ALBUQUERQUE
AQUAPONICS
512 YALE ST SE
Albuquerque, NM 87108

SITE PLAN

Historical Causes of Drainage / Elevation Problems Concerning 512 Yale SE, 2206-2210 Garfield SE and Adjoining Properties

Re: Brewstiller
500 Yale SE
Traffic Circulation Layout
Architect's Stamp dated 02-05-16 (K15-D099)

A1 NEW SITE PLAN

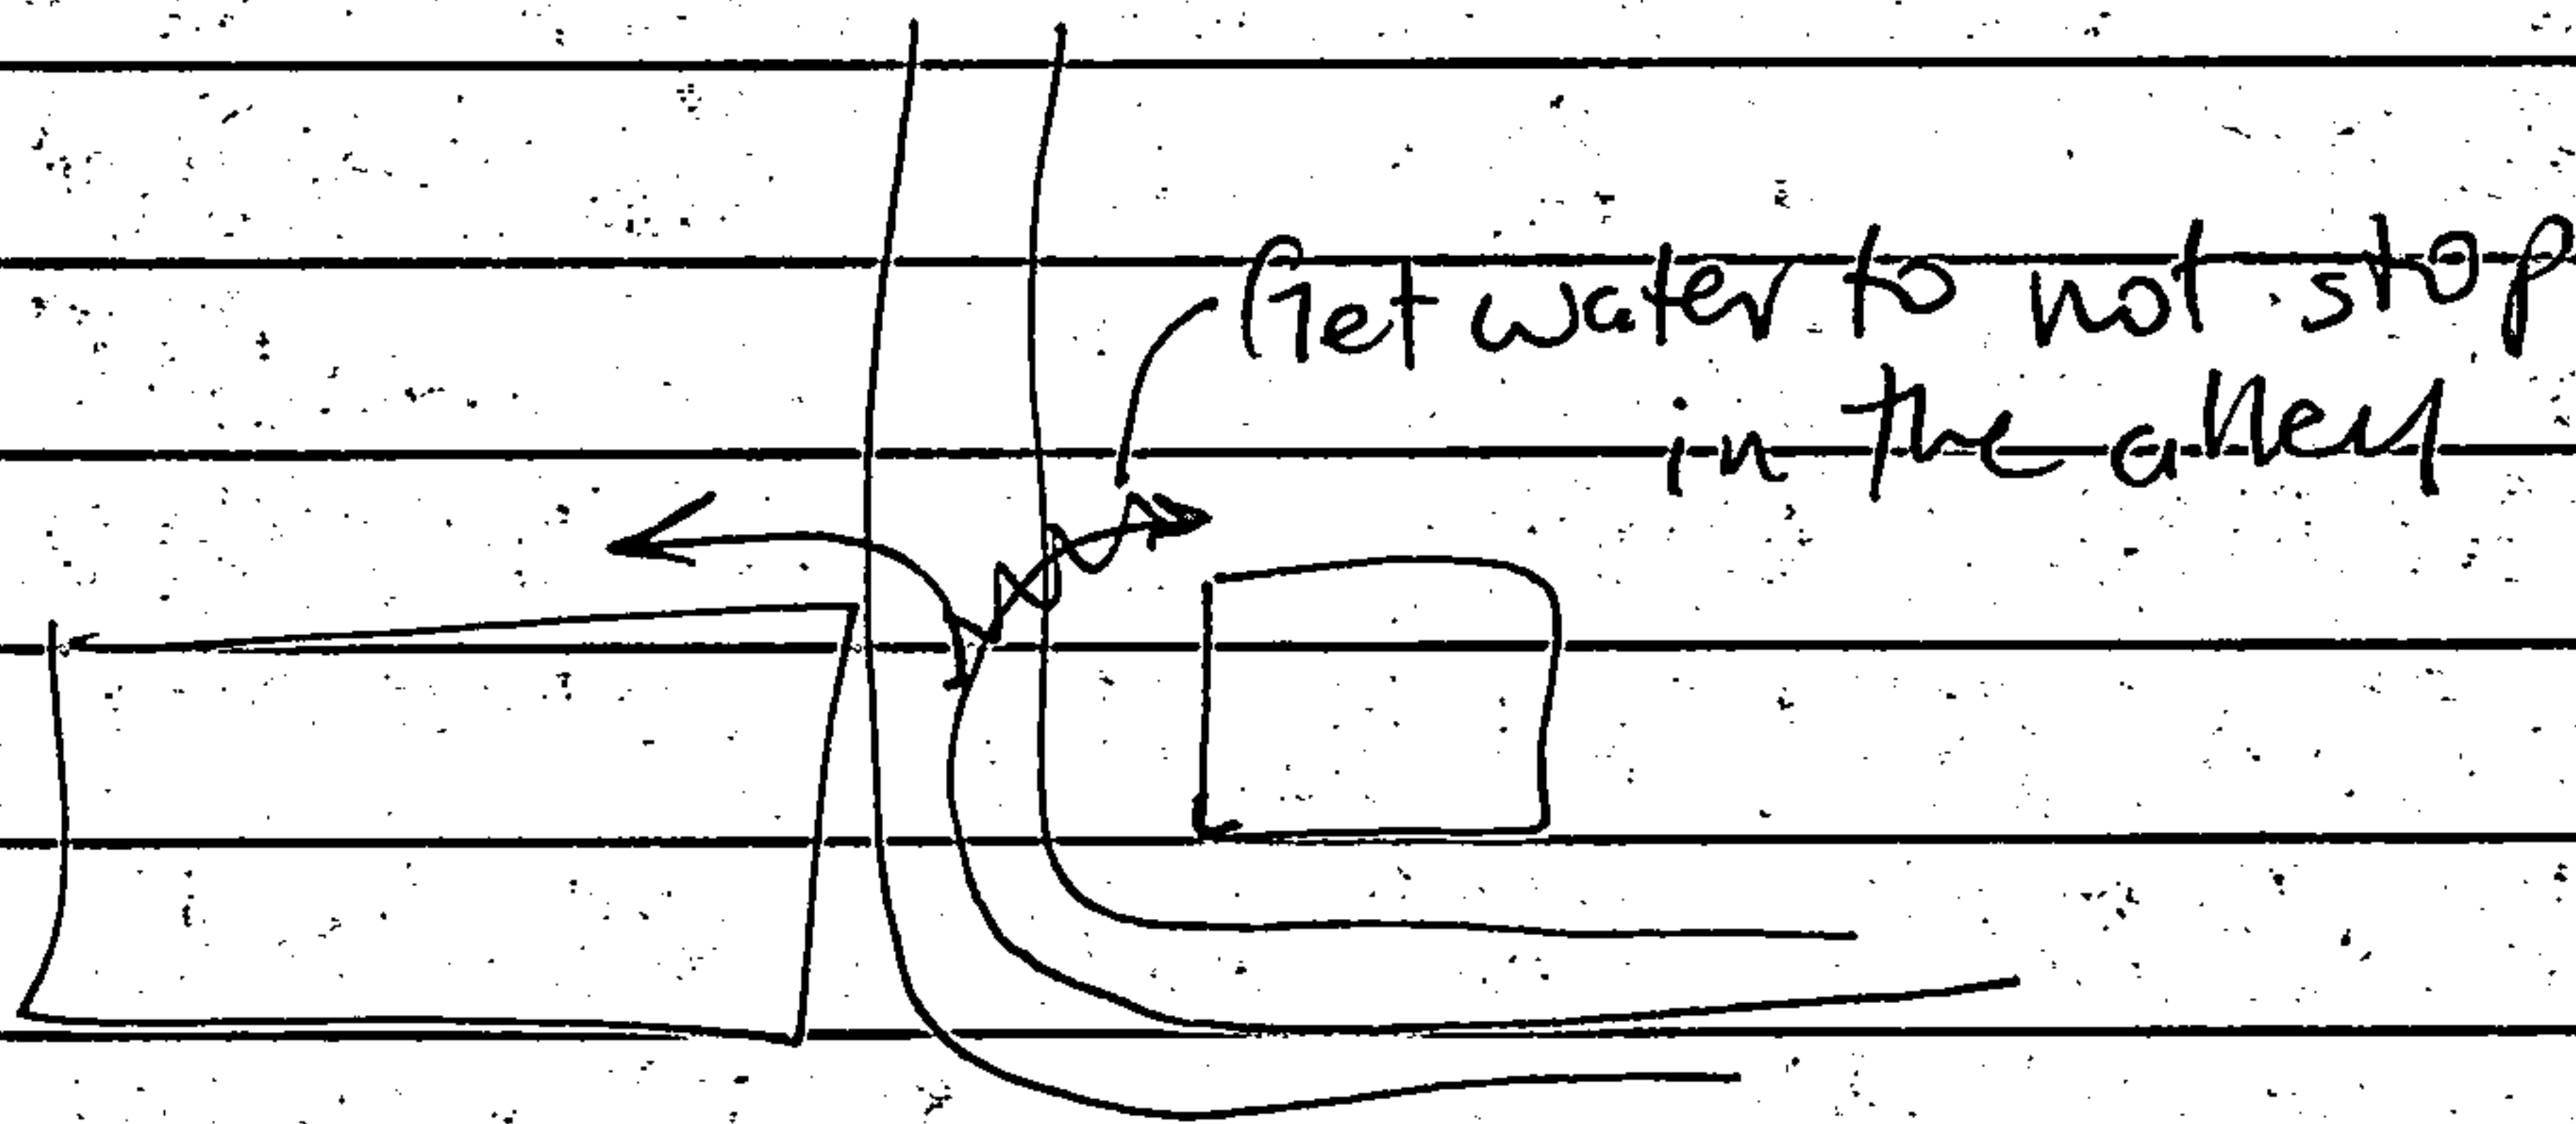
Kevin mentioned regrading the alley to direct flows through the parking lot

Alley is higher, runoff spreads out into the properties.

- I cannot tell where the property line is. There are 2 references.
The Property Line for 512 Yale lies right in the middle of the utility easement- The note calling out the CMU wall on cemetery property line should be revised to say "CMU WALL ON CEMETERY PROPERTY"

- The Utility easement appears to on property for 512 Yale, is this correct? Provide a plat is possible.
SEE ATTACHED SURVEY – 5' OF THE UTILITY EASEMENT IS ON 512 YALE PROPERTY

- What is the meaning of the dash-dot-dash lines? There are 3 lines and it is not clear
DASH DOT LINES REPRESENT SECURITY FENCING ON BOTH PLANS- WE ARE PROPOSING TO MOVE THE EXISTING FENCE ON YALE PROPERTY TO THE CEMETARY WALL TO CUT OFF THE EASEMENT FROM THE ALLEY

Kevin will work with maintenance
